# PB# 84-51

Dante Musco Subdivision 84-51

LANDS OF DANTE MUSCO

I have reviewed the subdivision entitled "Lands of dante Musco" in regards to water, sewer drainage and road section and have the following comments:

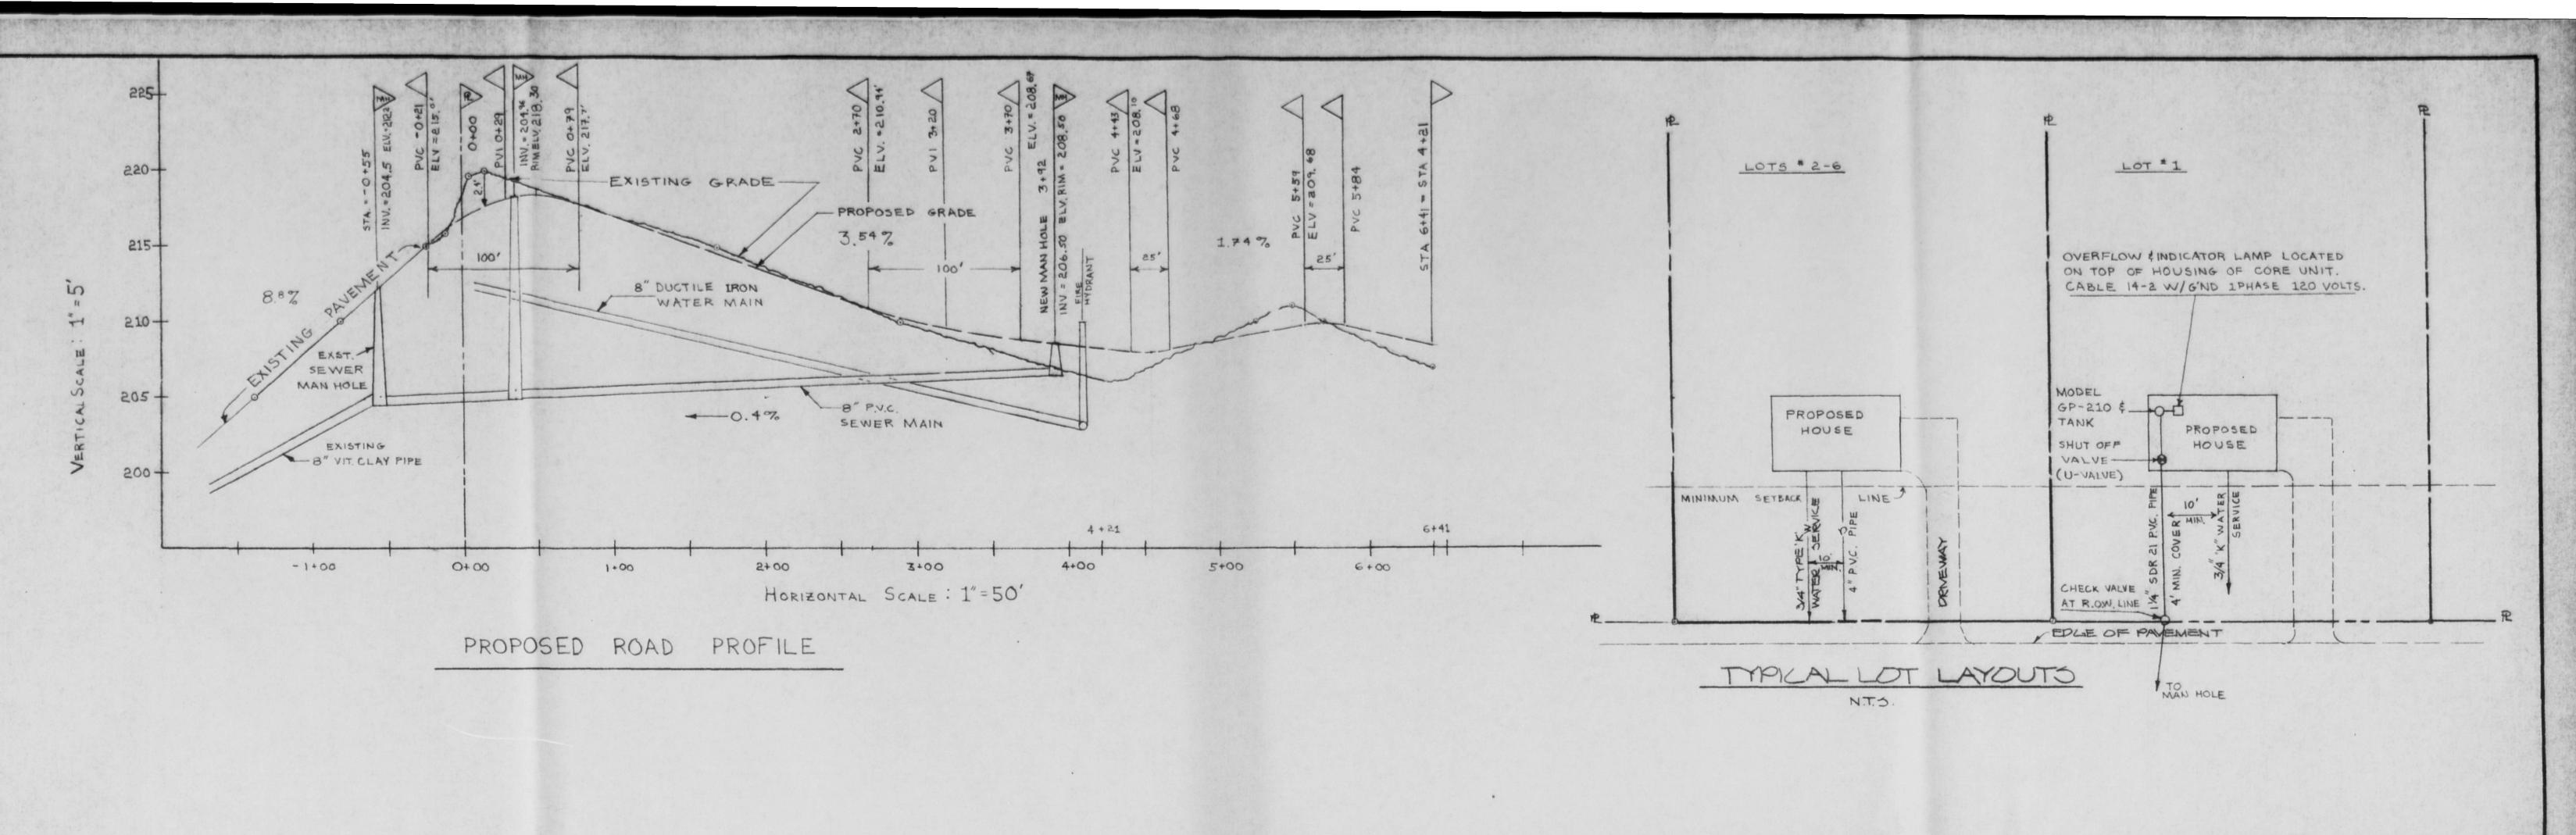
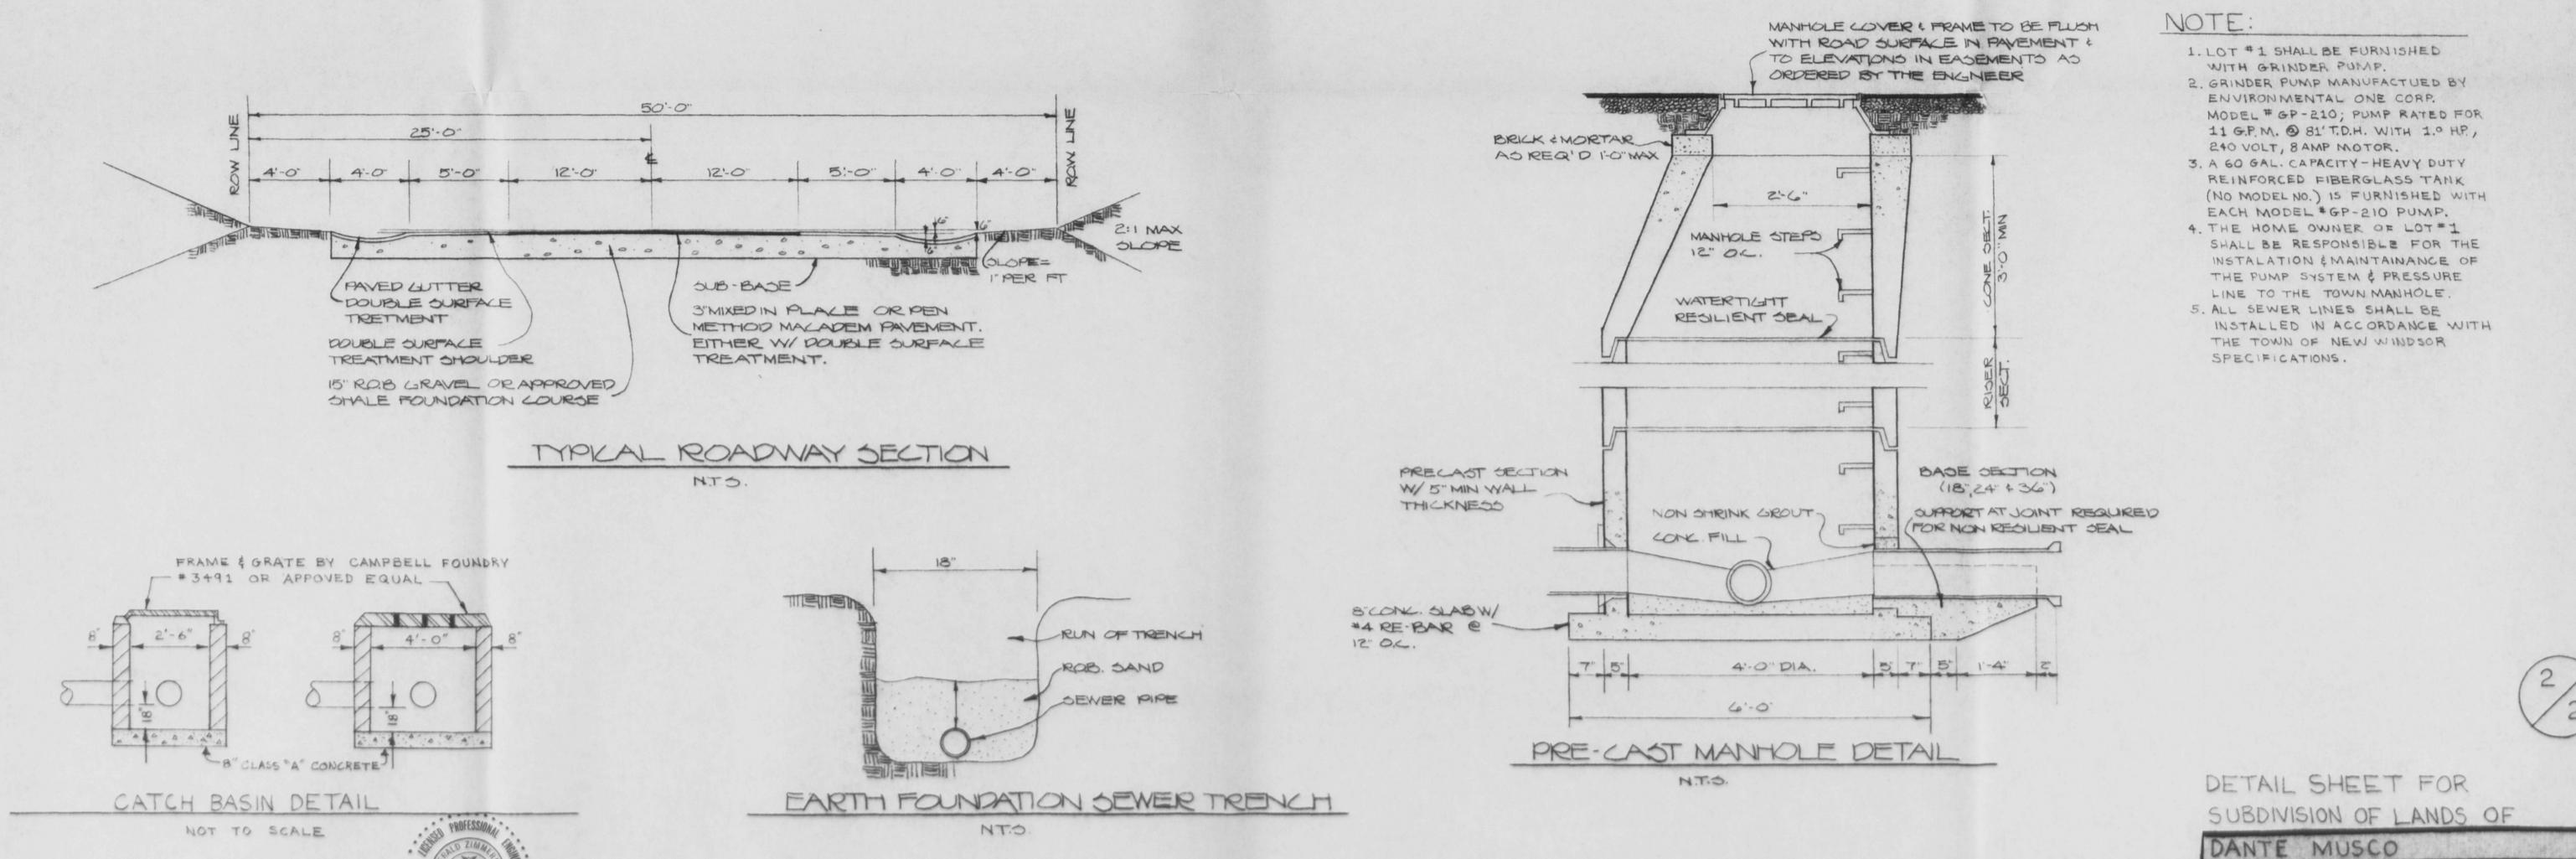
- 1. The developer should be told that before connecting to water at Mark St. the water department should be notified for assistance due to the maze water pipes that exist in Marks St.
- 2. Road section should conform to Town Specs.

3. I believe the 18" CMP main drainage pipe should be lengthened at least 20".

4 8" Water time
